ADDENDUM #2

IFB 17-07 HVAC System Replacement and Renovation West Loop Campus Project (LoanSTAR #1)

ITEM #1: Fire dampers at corridor duct penetrations.

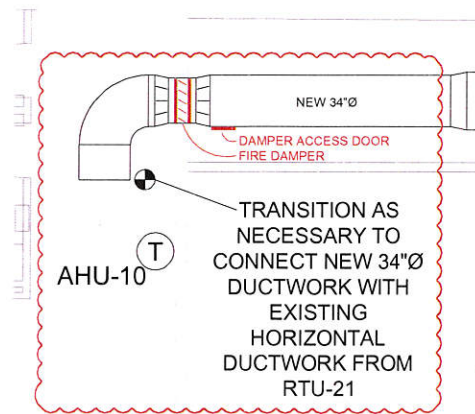
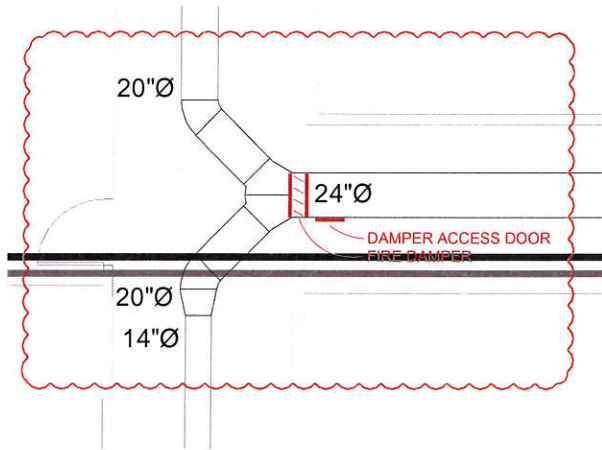
Please supply and install the following fire dampers at the indicated corridor duct penetrations at West Loop campus:

AHU	Duct	Duct Size	Dampers	Make and Model (pr Engineer approved equal)
9	Supply	24" Round	24"	Ruskin FDR25 Round Fire Damper Damper
10	Supply	34"ø to 30x30	1 each 30x30	Ruskin DFD35 Multiple Blade Dynamic Fire Damper

Include 16x12 damper access/inspection door [Ruskin AHR24] each supply duct damper location on most-accessible side of damper.

Note that 34" round duct will require transition to 30x30 duct immediately before and after installation of fire damper at wall penetration.
